Environmental and Ecological Planning Advisory Committee

12th Meeting of the Environmental and Ecological Planning Advisory Committee
November 15, 2018
Committee Rooms #1 and #2

5.4 EIS Review Comments Spreadsheet - Southdale West Improvements - Pine Valley to Colonel Talbot Road

5.8 William Street Outfall - Class Environmental Assessment and Environmental Impact Statement - Response to Comments Provided

**FIGURE 2
STUDY AREA**

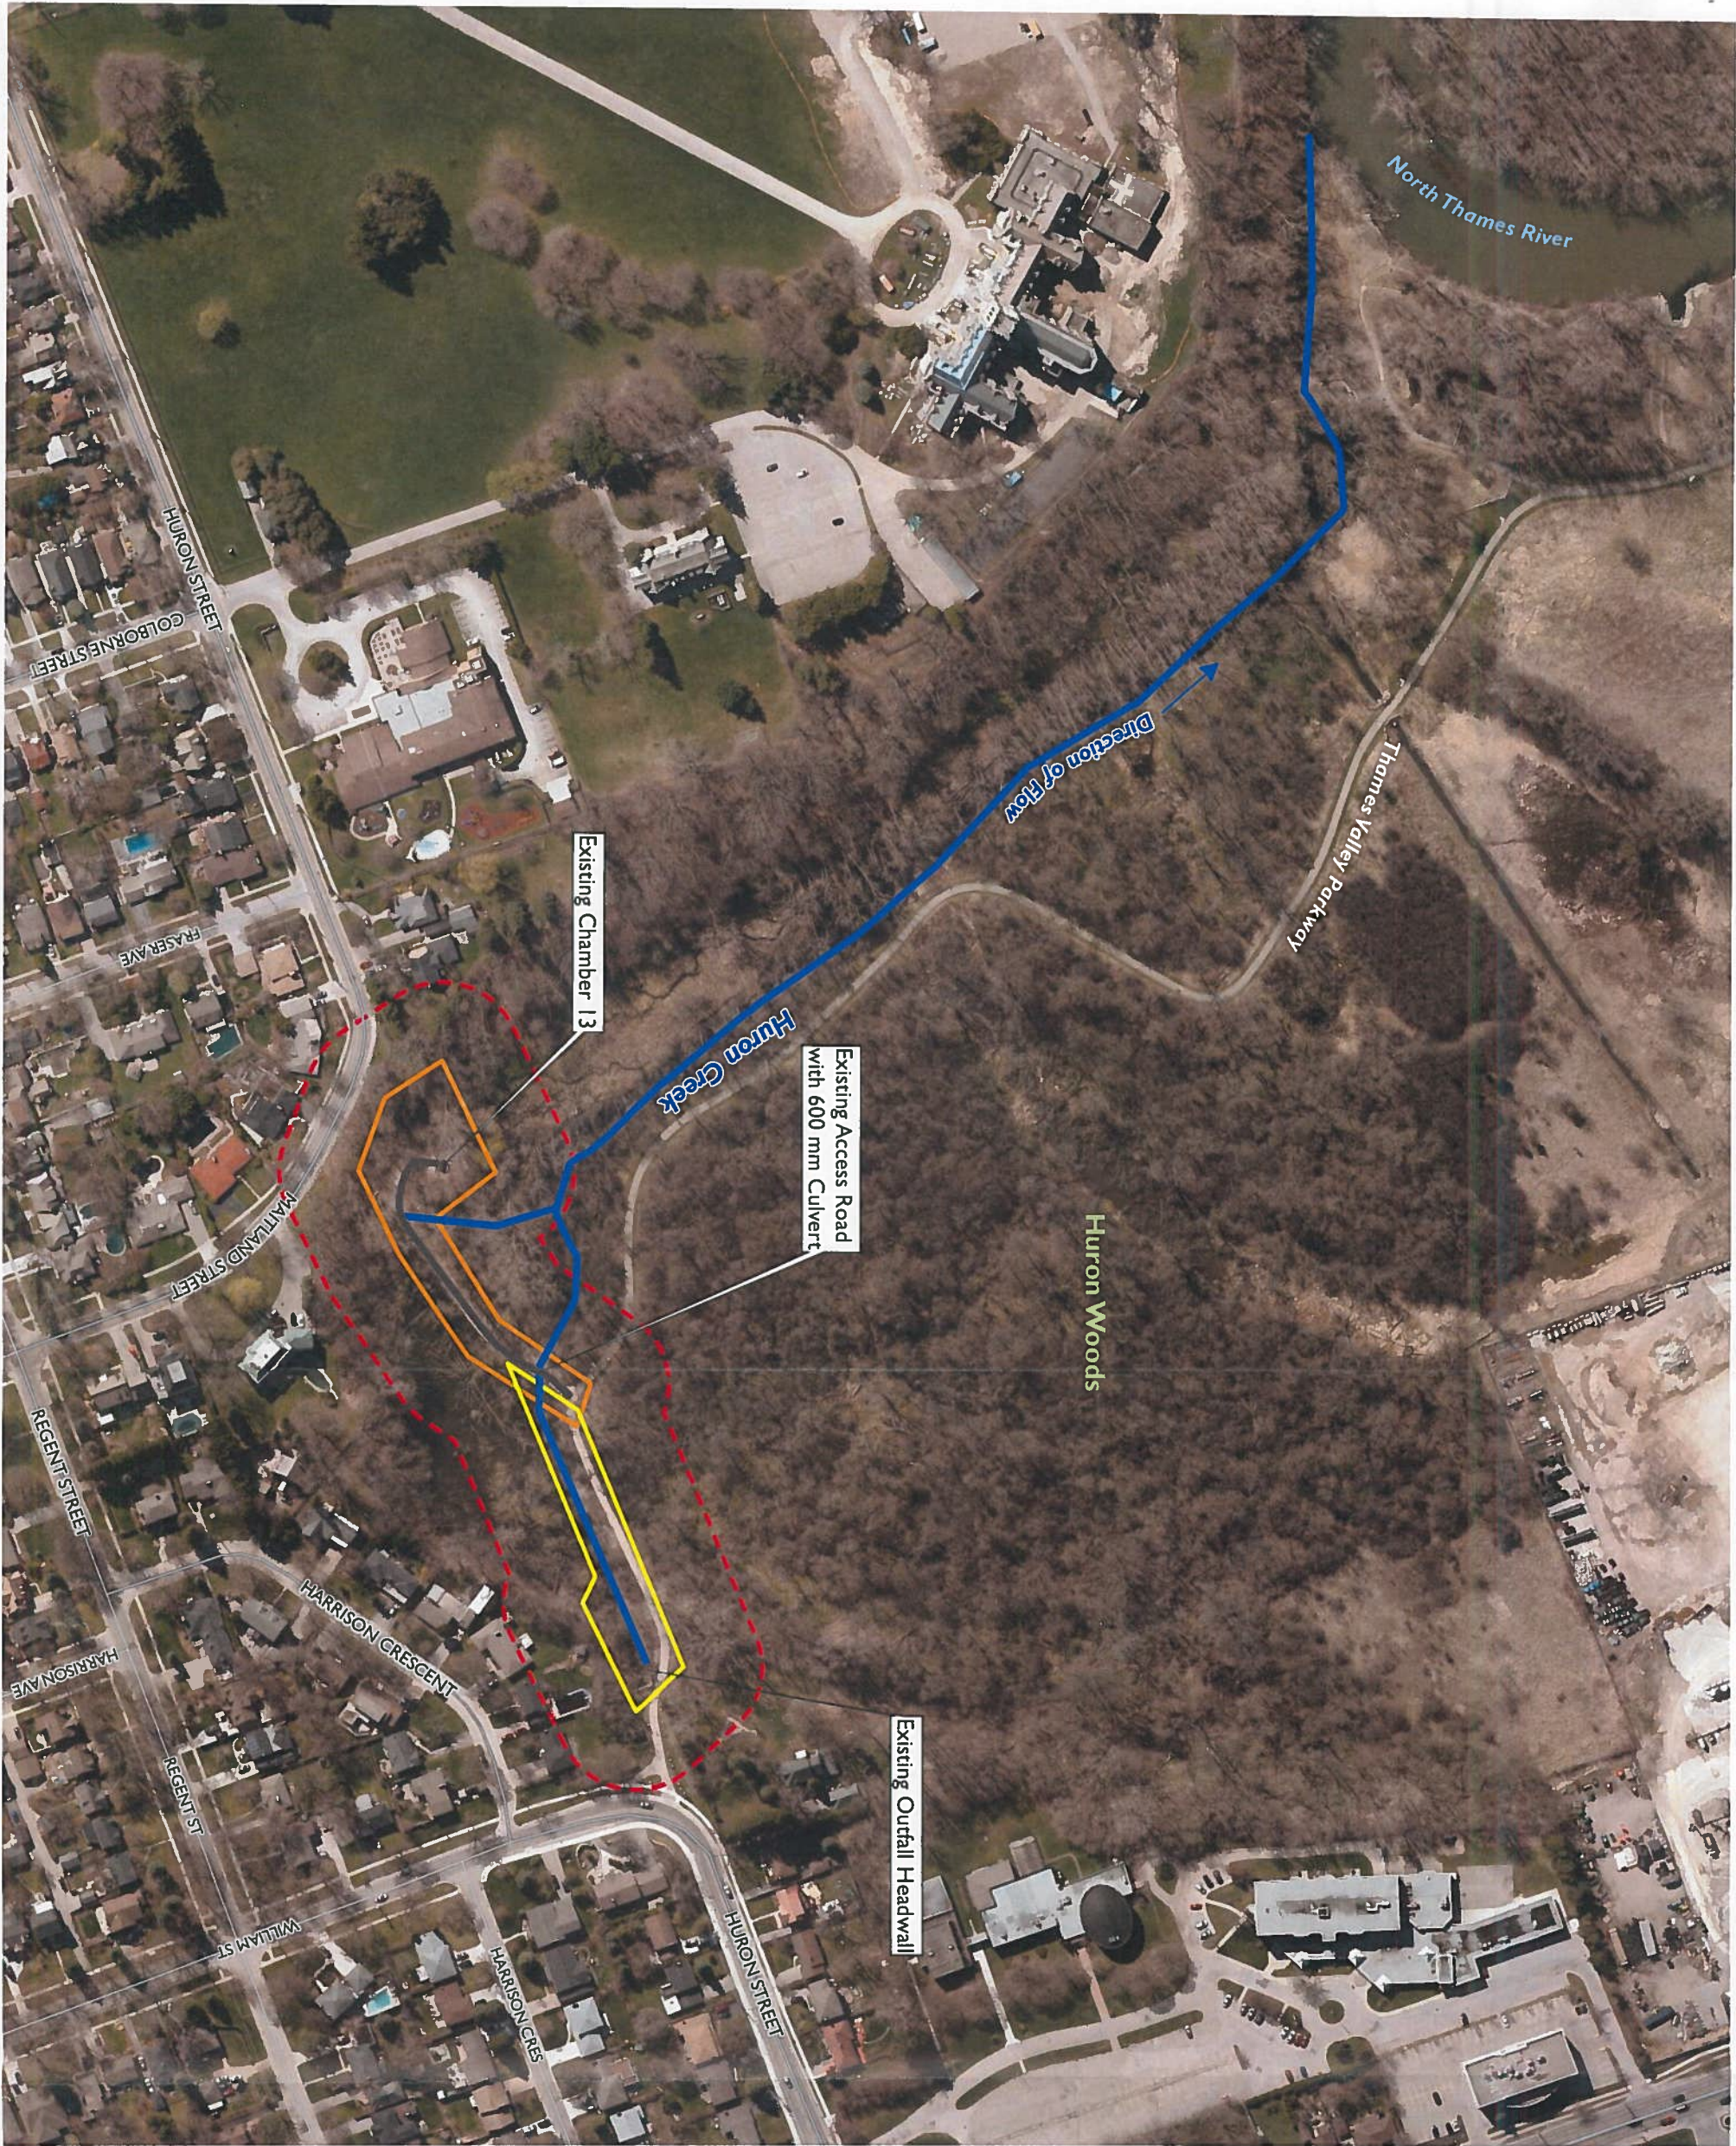
Subsequent to submitting the Draft EIS for review, the project was revised to include the potential decommissioning/abandonment of Watermain Chamber 13, located just west of the channel (see attached **Figure 2**). Immediately north of the low flow channel, there is an existing 600 mm watermain. The watermain is connected to Chamber 13. The existing maintenance road is in place to provide access the chamber.

The City is planning to abandon and relocate the 600 mm watermain so that is no longer within Huron Street Woods. The new watermain would be located along a municipal road right-of-way, providing improved access for maintenance activities. When the watermain is relocated, Chamber 13 would be abandoned. As a result, the existing maintenance road and associated culvert would be removed and the area restored to be consistent with the surrounding landscape. The details regarding the watermain relocation are still being finalized, including timing of the work.

**FIGURE 3
NATURAL ENVIRONMENT
EXISTING CONDITIONS**

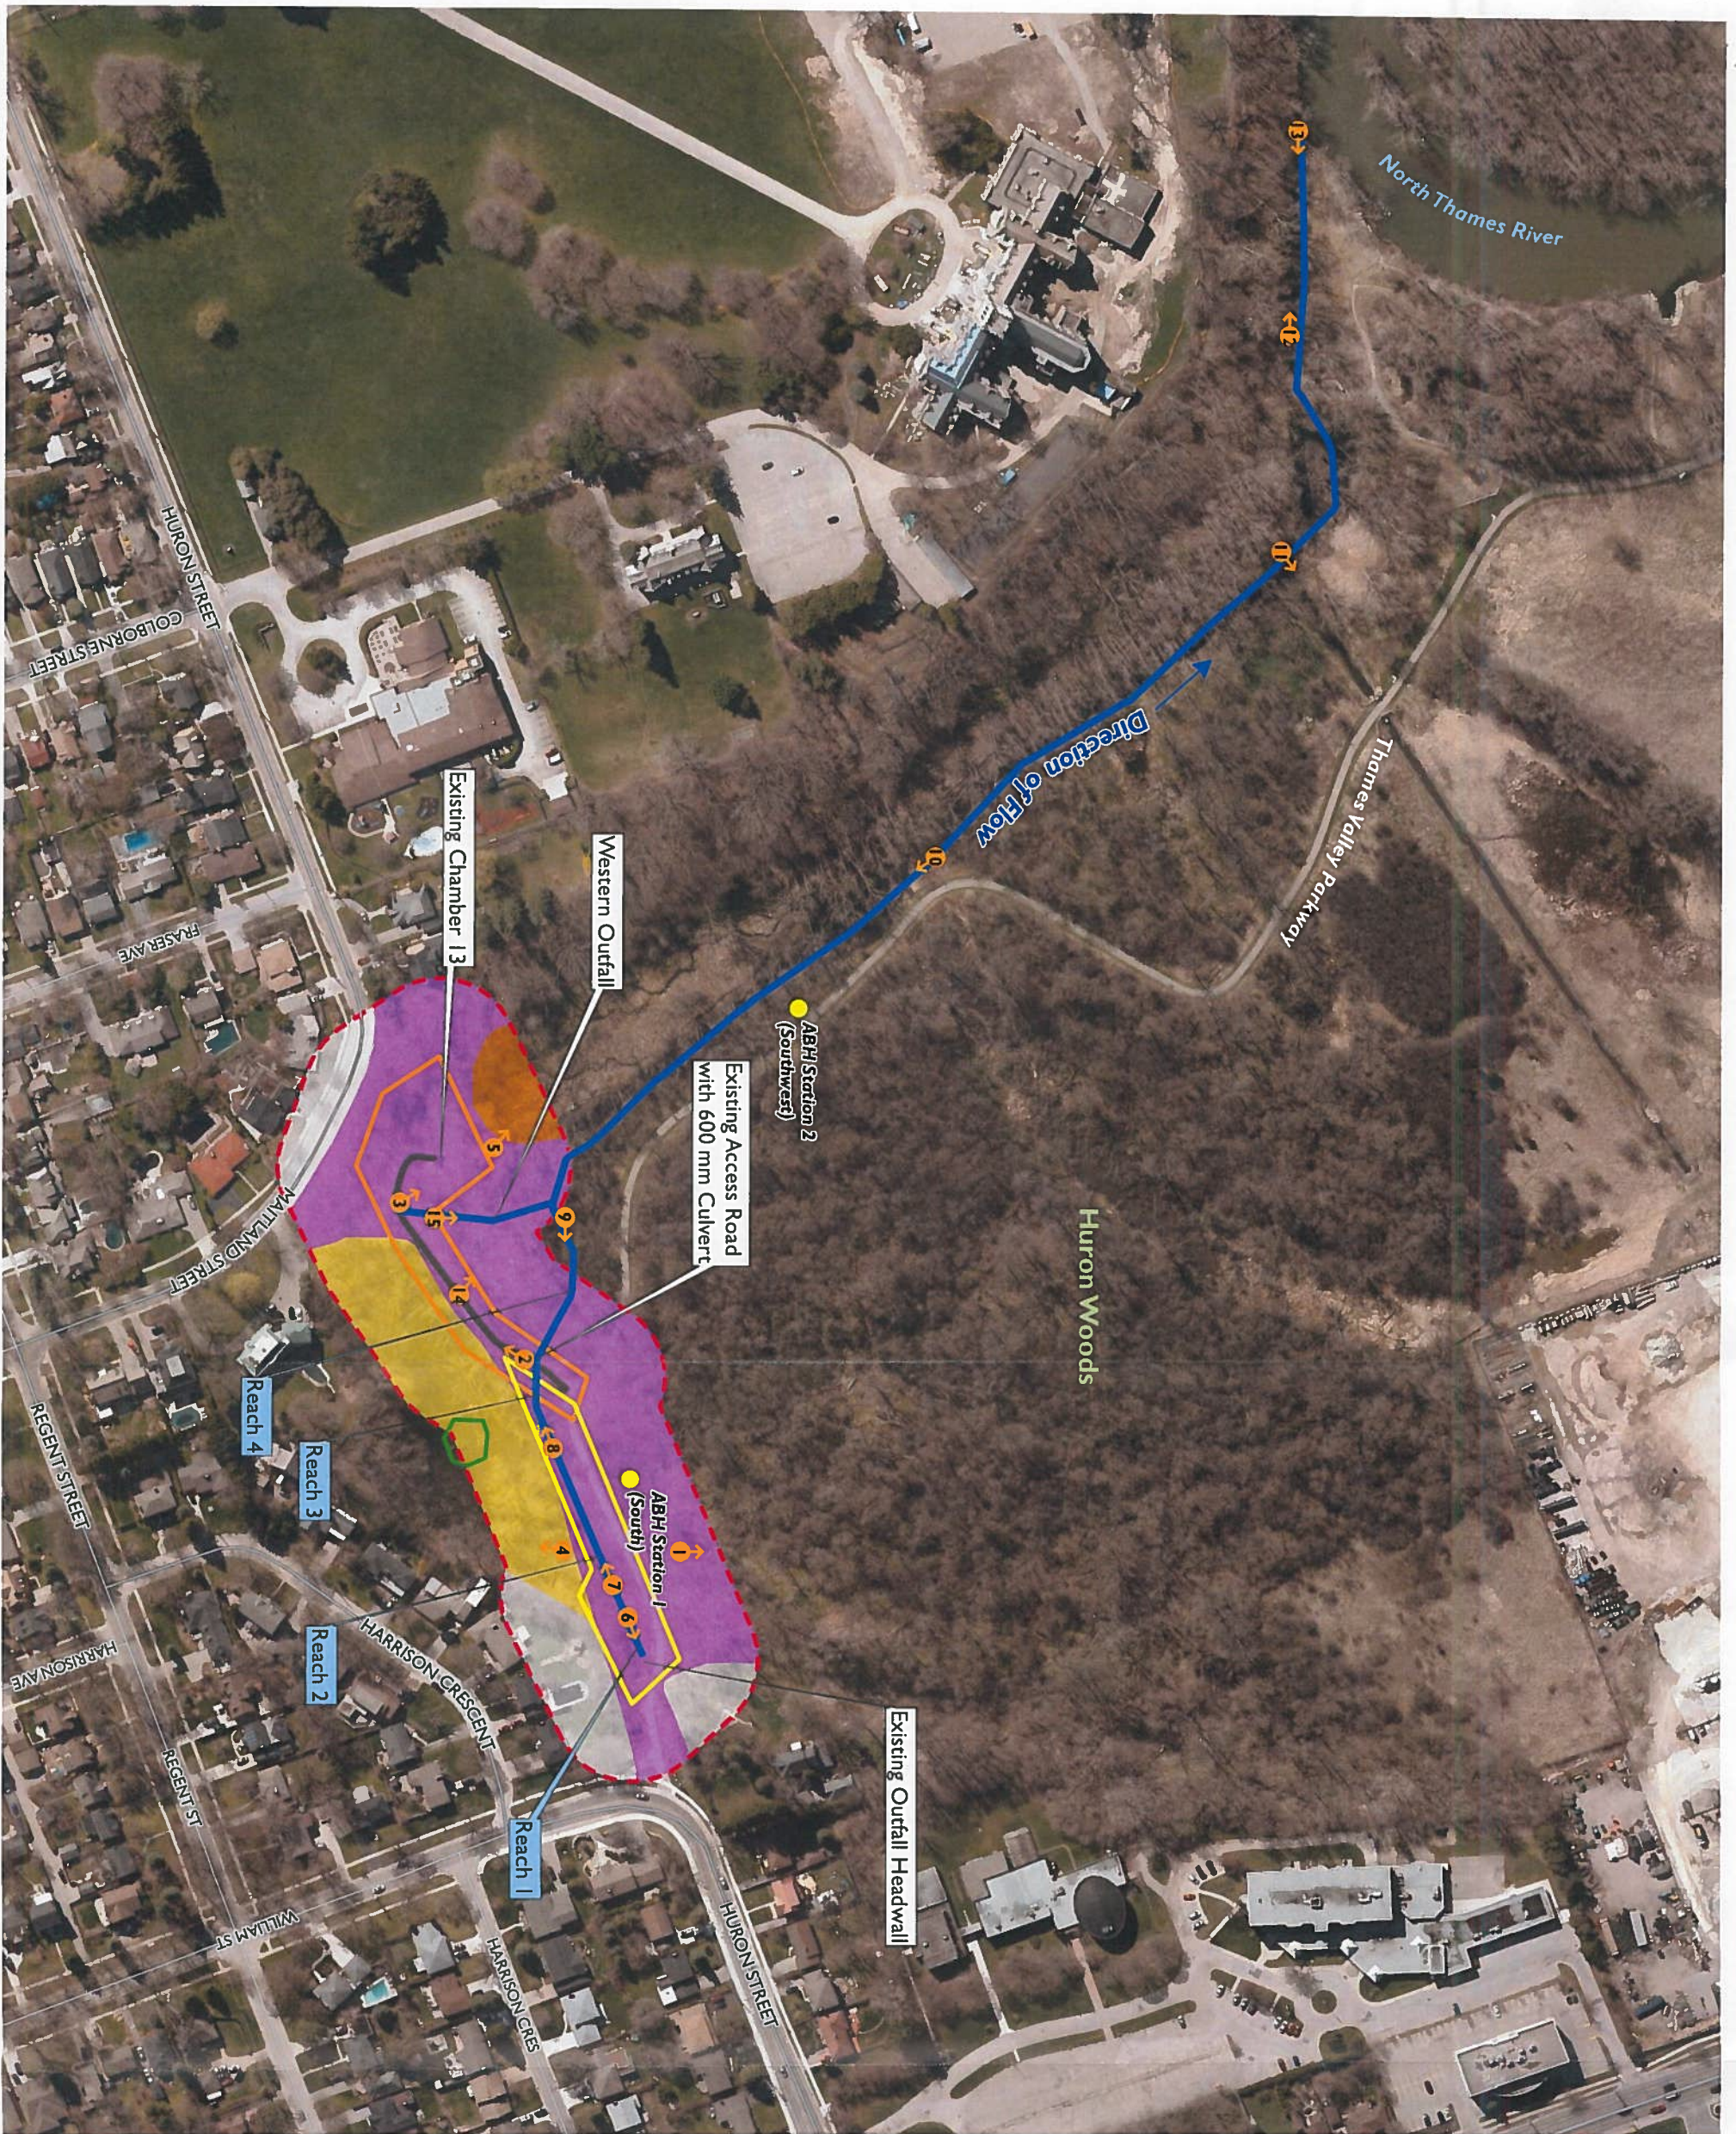
EEPAC RECOMMENDATION 1: The proposed Invasive Species Management Plan mentioned on page 28 of the EIS includes a buckthorn herbiciding program within the project budget for the city lands north of the channel within the study area.

Study Team Response to Recommendation 1: The EIS has been updated to include an Invasive Species Management Plan (ISMP) within the document, with steps to address the Phragmites and Buckthorn. The ISMP is consistent with and references the London Invasive Plant Management Strategy. Methods for control are referenced from the applicable Best Management Practice documents for the target species from the Ontario Invasive Plant Council and the Ministry of Natural Resources and Forestry (MNR), as well as recent 2017 technical bulletins from the OIPC. The EIS has been updated to more widely define the areas subject to the ISMP, which now includes the approximate footprint of the project work areas plus a surrounding 30 m buffer (shown as the study area on **Figure 3** of the EIS).
